**Public Review
Of
Draft Management Plan No. 3**

**(October 23rd, 2000 – November 21st, 2000)
(February 7th, 2001 – March 9th, 2001)**

Thank you for your letter of March 15, 2001 in which you provide comments on draft Management Plan No. 3 for TFL 47.

Figure 6-3. Growing stock for Base Case Harvest Simulation for the Johnstone Straits Management Unit.

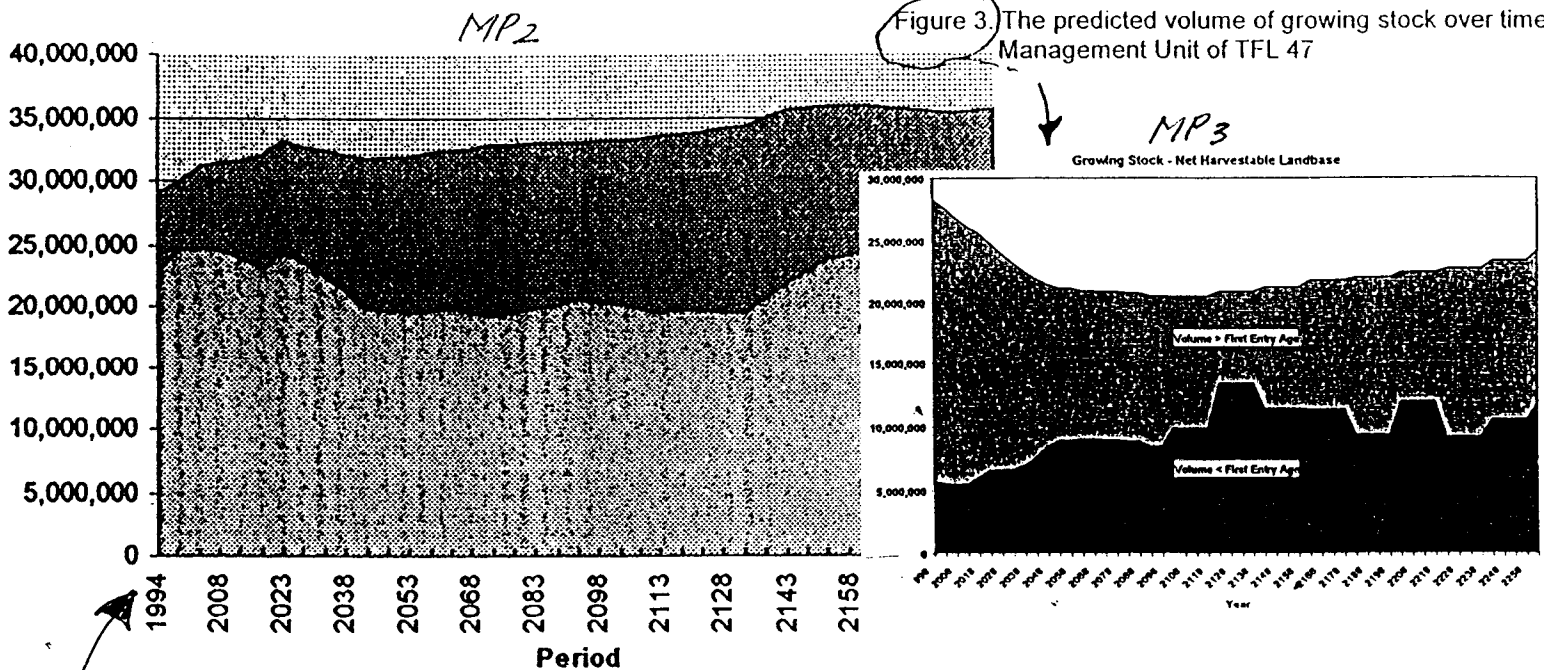
In the Base Case, after an initial decline for 50 to 60 years, the growing harvestable landbase gradually increases. (figure 3)

In summary, the 24% increase in MP2 was bad enough. More gradually introduced increases can lead to a much greater LRHL than the large, hasty increases would. MP3's proposed level of 559,350 m / yr. is not even sustainable after MP3 and the longer that future reductions were delayed, the larger they would have to be. An LRHL of 559,350 is not even a worthy goal. Heavy cutting of the remaining old growth is not an option in this Unit. Any increase to harvest level in MP3 is unsupportable even by the narrow criteria of Management Plan review.
